Project: Weed Corley Fish Funeral Home, Leander, TX

Re: Question & Answer

Bid Clarification: #1

Architectural Site Plan
Project Number: 230502
N-vizion Design, LLC - 5900 Shepherd Mountain Cove, Ste. 2250
Registration No.: TX PE Firm F-1223, TX 25488, LA 6413 MI
1301069561, NV 6252, NC: 14883, OH: ARC-1917785

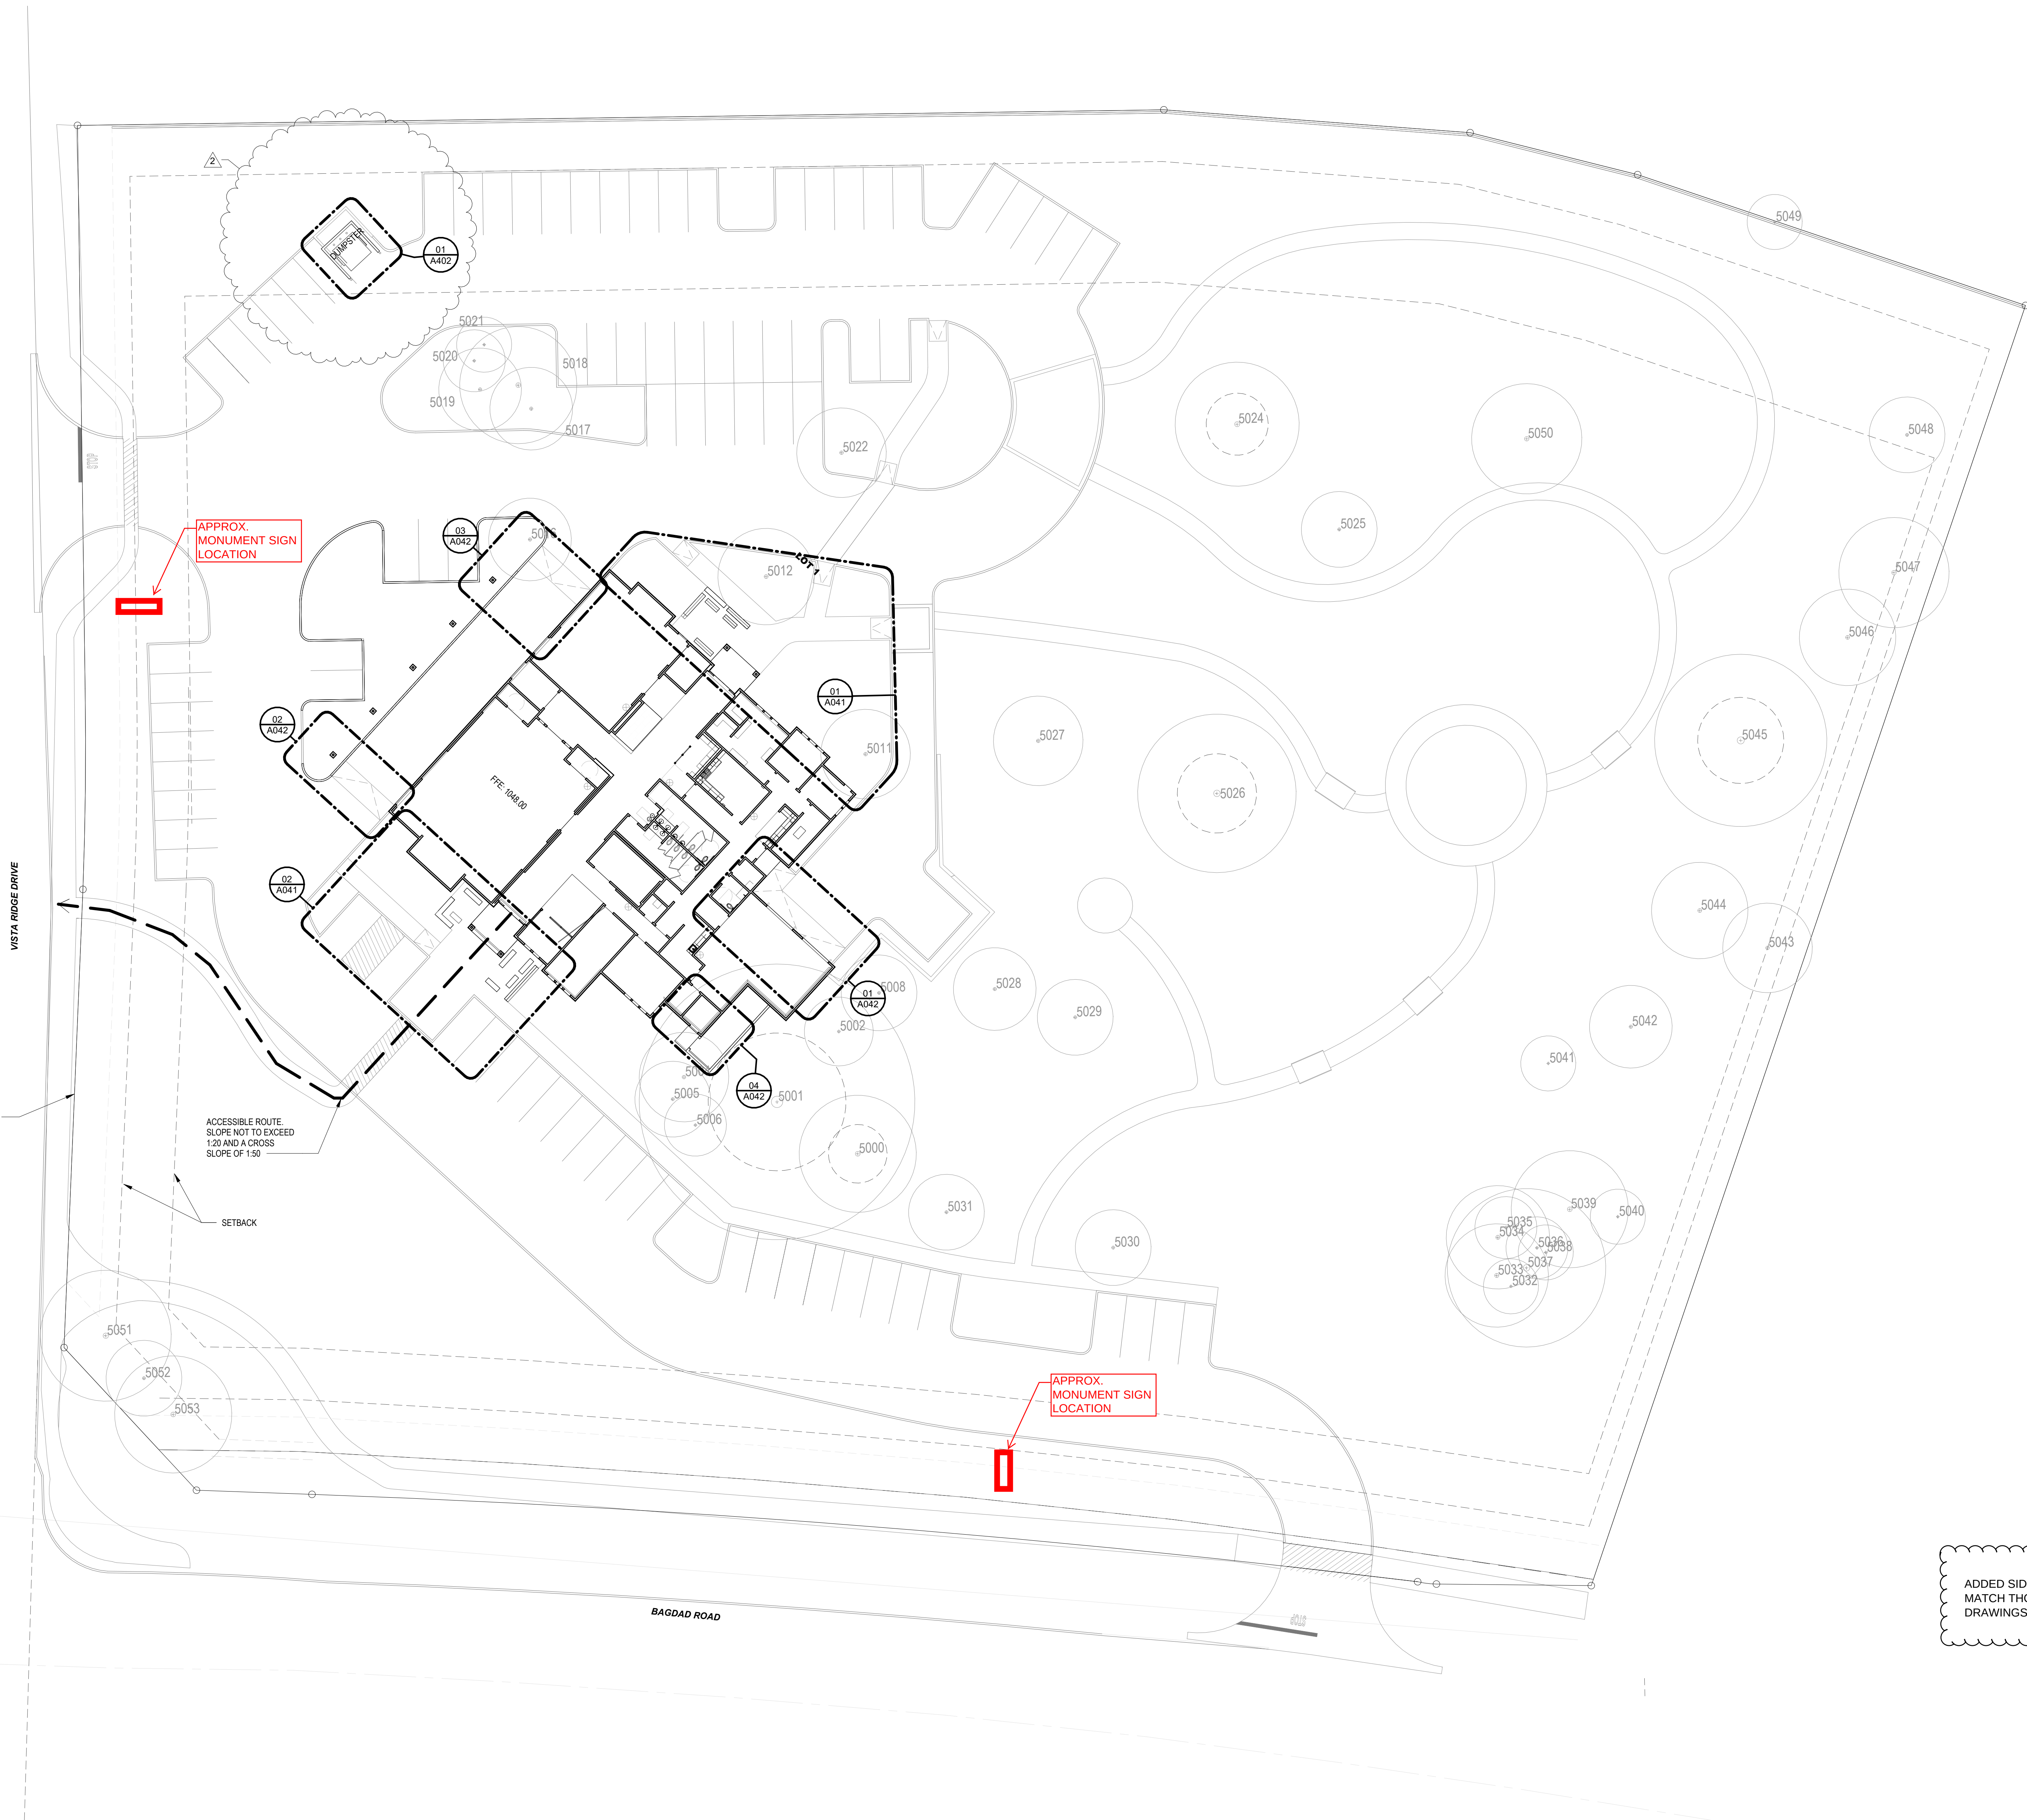
ADDED SIDEWALKS AT STREET. SHOWN TO MATCH THOSE SHOWN ON THE CIVIL DRAWINGS.
